HISTORIC AND DESIGN REVIEW COMMISSION

May 18, 2022

HDRC CASE NO: 2022-231
COMMON NAME: 1111 & 1115 N Palmetto
LEGAL DESCRIPTION: NCB 1302 BLK 3 LOT E 144.84 FT OF 10
ZONING: R-5, H
CITY COUNCIL DIST.: 2
DISTRICT: Dignowity Hill Historic District
APPLICANT: James Benfield/Benfield Real Estate
OWNER: James Benfield/Benfield Real Estate
TYPE OF WORK: Amendment to a previously approved design regarding window materials, siding profile and appearance, and fenestration profiles
APPLICATION RECEIVED: May 11, 2022
60-DAY REVIEW: Not applicable due to City Council Emergency Orders
CASE MANAGER: Edward Hall

WINDOW MODIFICATIONS:

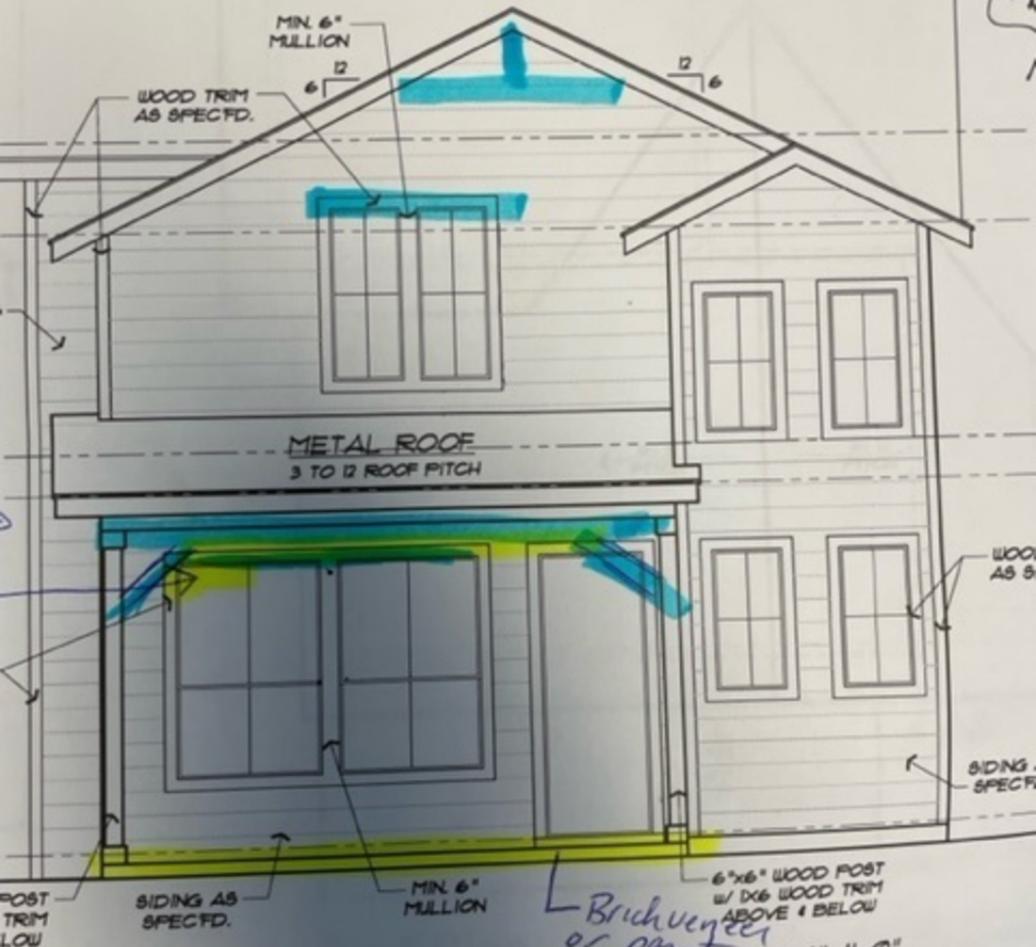
- CUT FLANGE TO PUSH WINDOW INTO FRAME. TO MEET SPECS
- CUT CUSTOM BEVELED TRIM AT BOTTOM SASH TO MEET SPECS
- CUT CUSTOM TRIM AT EACH WINDOW SO THE UPPER AND LOWER SASH MEET WIDTH SPECS
- PAINTED WINDOW TO GIVE CUSTOM LOOK AND MEET SPECS

Left Elevation SCALE: 1/4"=1'-0"

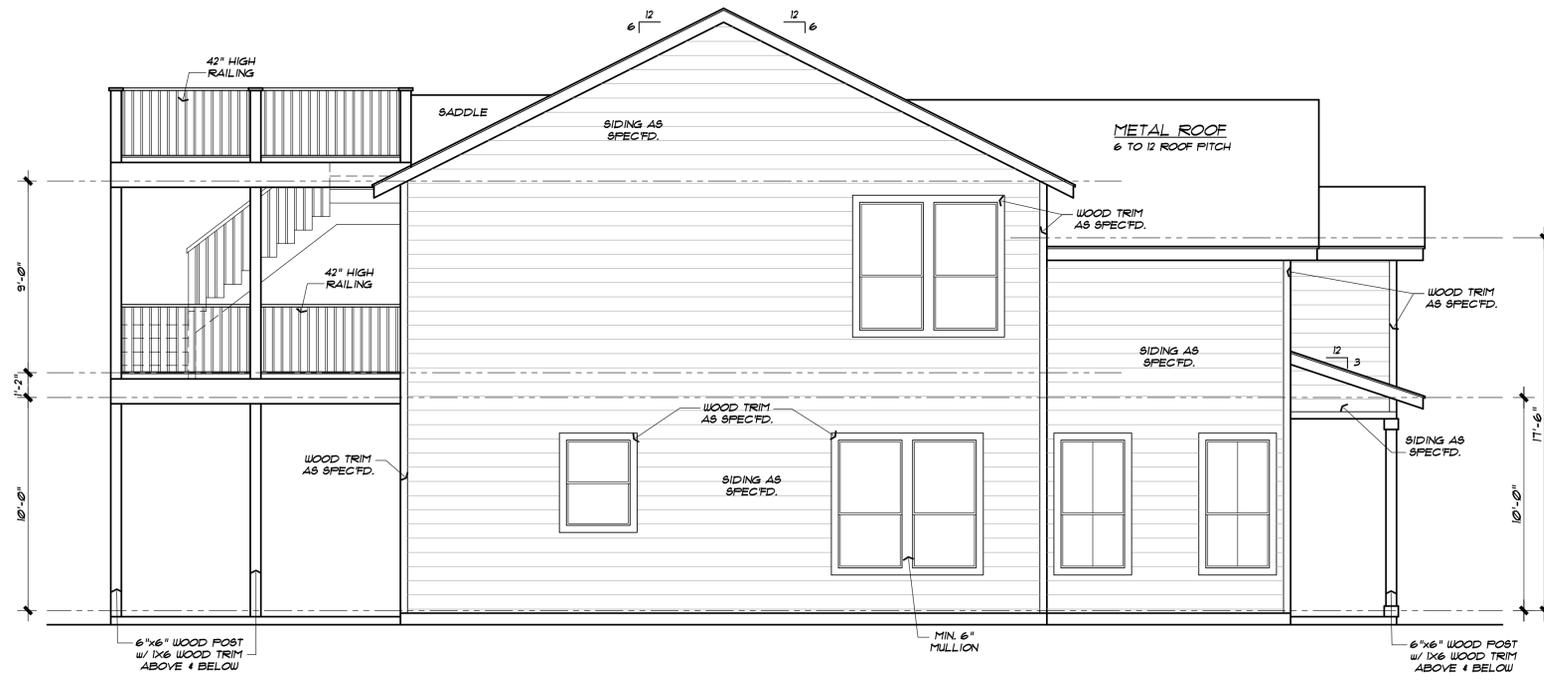
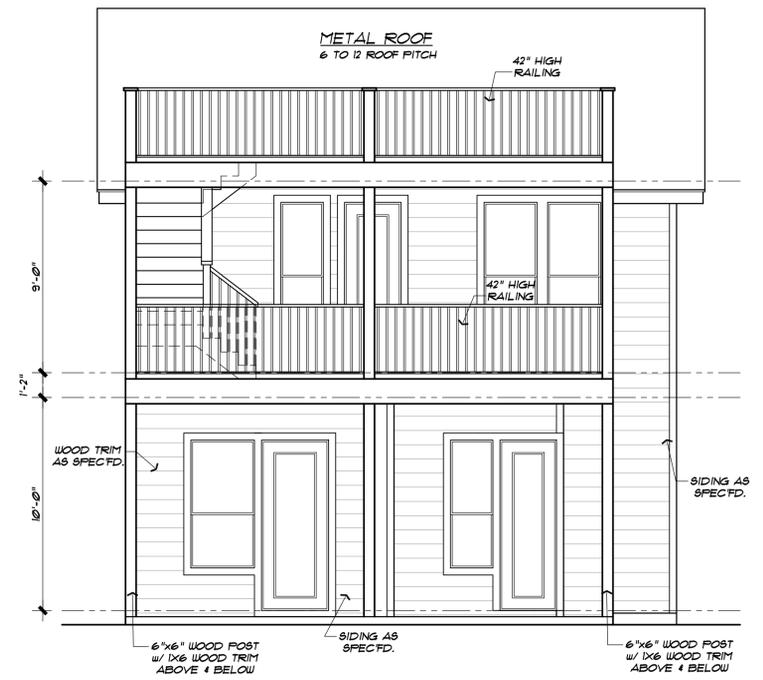
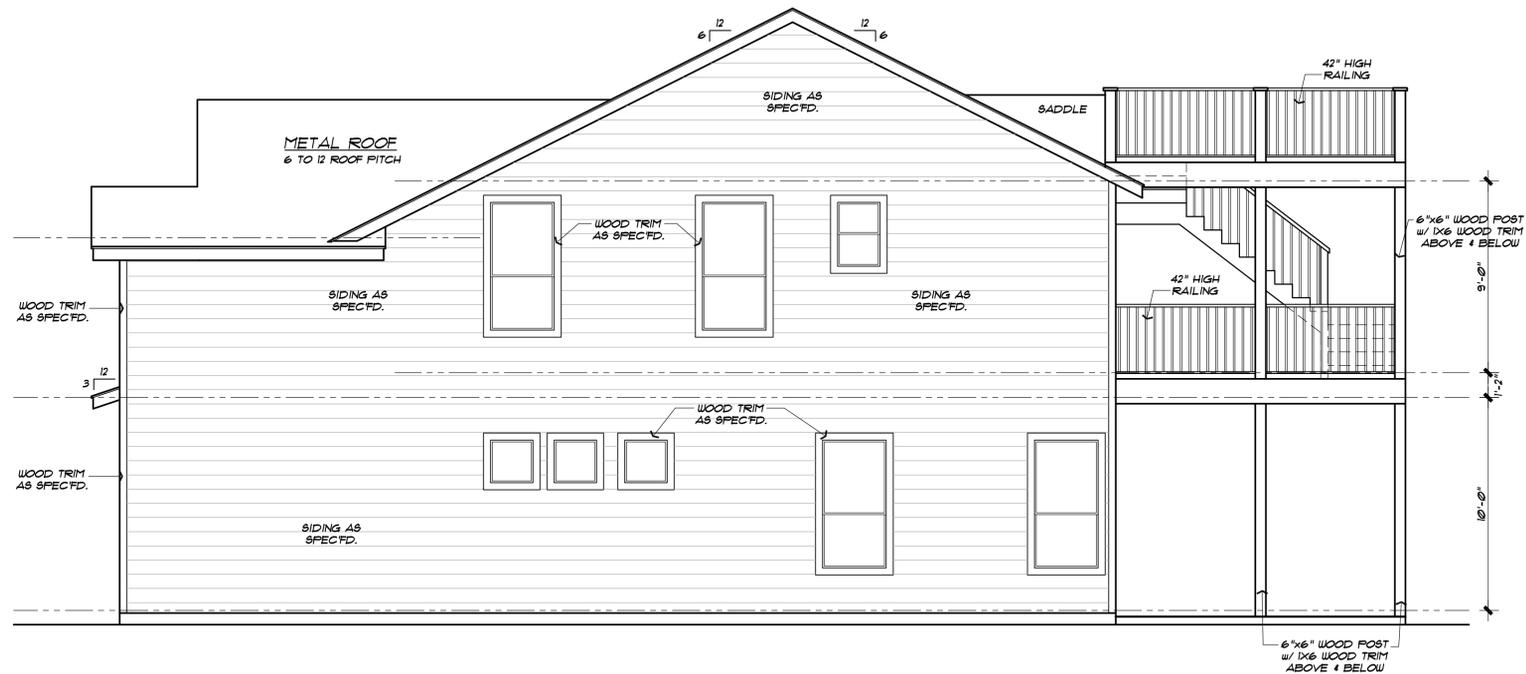
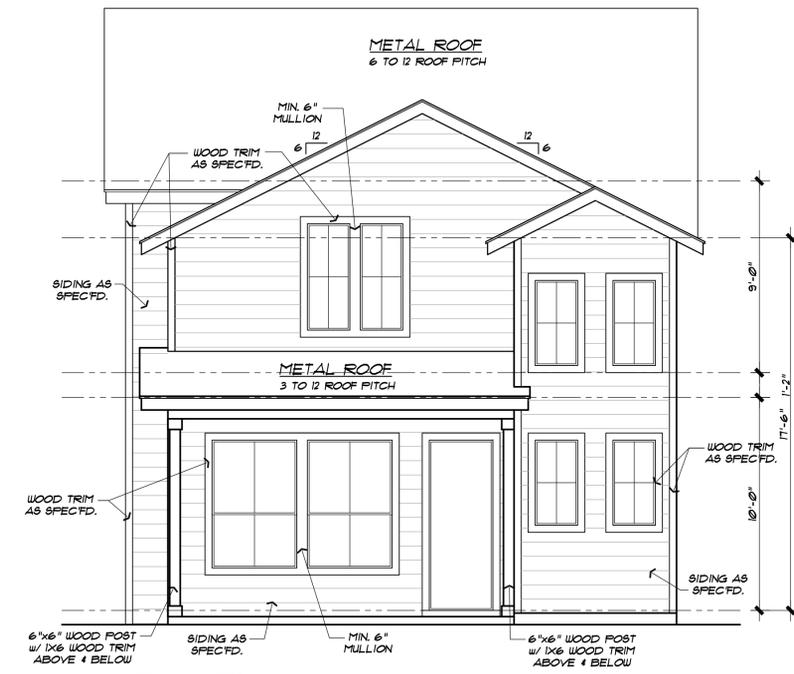
- d. FENESTRATION & DESIGN – The applicant has proposed to amend the previously approved design by modifying the previously approved fenestration pattern for both structures on the north, south and east facades as well as modify the rear design of both structures. These modifications include modified window locations, modified window sizes, and the removal of the previously approved rear balcony elements. Staff finds that the original design should be adhered to, as shown in the original construction documents, as it relates to all fenestration.

2. Staff does not recommend approval of item #2, modifications to existing fenestration and design based on finding d. Staff recommends that the original design should be adhered to, as shown in the original construction documents, as it relates to all fenestration.
